service bulletin

No. 97-20

EFI and MPI Fuel Line Replacement

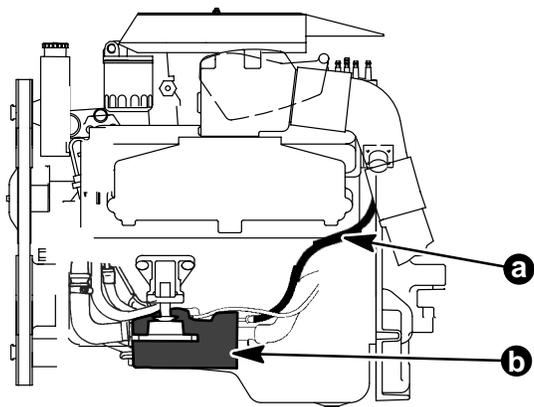
1. MCM 4.3L EFI, 5.0L EFI, 5.7L EFI (TBI) Sterndrive Engines:

Look at the fuel cooler to TBI fuel line. If it is braided, the fuel line IS GOOD and does not have to be replaced.

- a - Fuel Line to TBI
- b - Fuel Cooler.
- c - Braided Fuel Line.

2. 1997 MCM 7.4LX MPI, 454 Mag MPI, 502 Mag MPI Sterndrive Engines:
1997 MIE 7.4L MPI, 8.2L MPI Inboard Engines:
1998 MCM 7.4L MPI, 454 Mag MPI, 502 Mag MPI Sterndrive Engines:
1998 MIE 7.4L MPI, 454 Mag MPI Horizon, 8.2L MPI Inboard Engines:

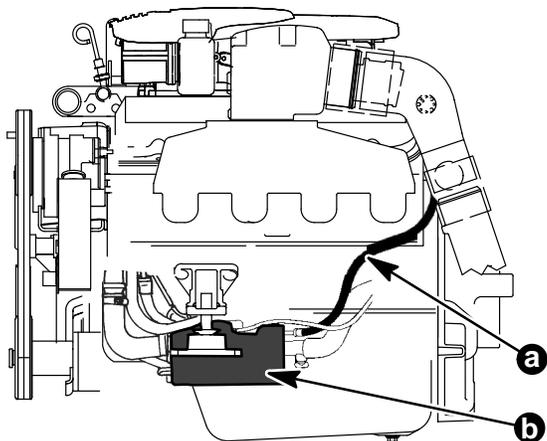
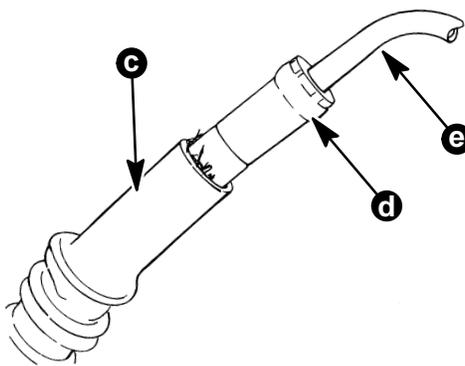
Look at the fuel cooler to fuel rail line. If the fuel line has a 'fire sleeve' AND the metal hose coupler is brass, the fuel line IS GOOD and does not have to be replaced.

- a - Fuel Line to Fuel Rail.
- b - Fuel Cooler.
- c - 'Fire Sleeve' Pulled Back.
- d - Brass Hose Coupler.
- e - Stainless Steel.

3. 1997 MCM 350 Mag MPI Sterndrive Engines:
 1997 MIE Black Scorpion MPI Ski, 377 Scorpion MPI Ski Engines:
 1998 MCM 350 Mag MPI Sterndrive Engines:
 1998 MIE 350 Mag MPI Ski Engines:
 1998 MIE 350 Mag MPI Inboard Engines:

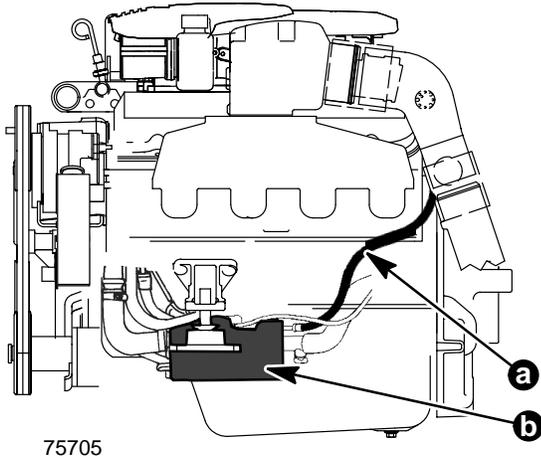
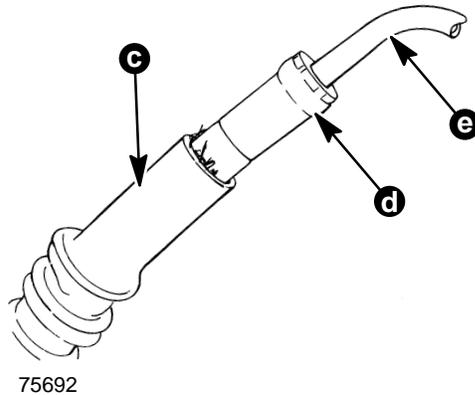
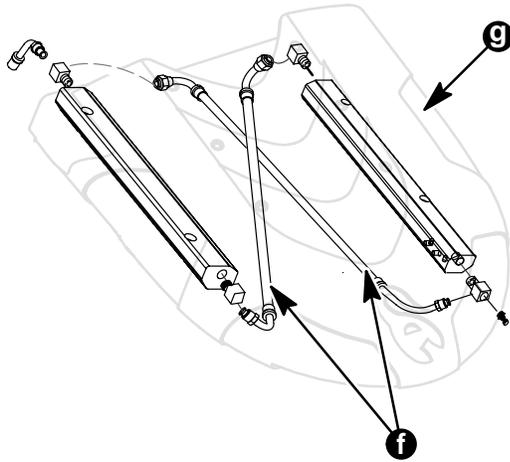
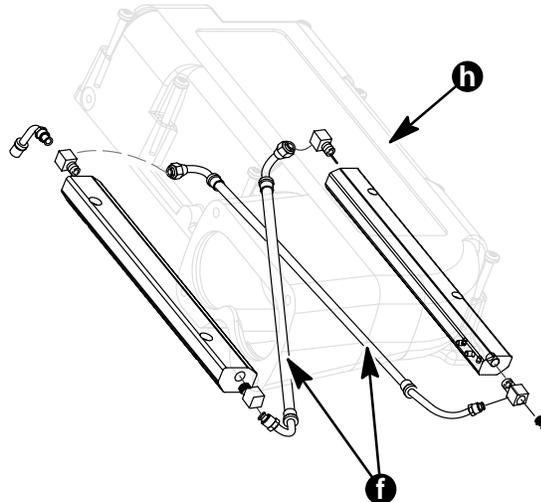
- a. Look at the fuel line to fuel rail line. If the fuel line has a 'fire sleeve' AND the metal hose coupler is brass, the fuel line IS GOOD and does not have to be replaced.
- b. Also look at the 2 rail to rail fuel lines. If the fuel lines have a 'fire sleeve' AND the metal hose couplers are brass, the fuel lines ARE GOOD and do not have to be replaced.

- a - Fuel Line to Fuel Rail.
- b - Fuel Cooler.
- c - 'Fire Sleeve' Pulled Back.
- d - Brass Hose Coupler.
- e - Stainless Steel.
- f - Rail to Rail Fuel Lines.
- g - Scorpion Intake Plenum.
- h - 1997 350 Mag MPI Plenum. Not On 1998 350 Mag MPI Engines.
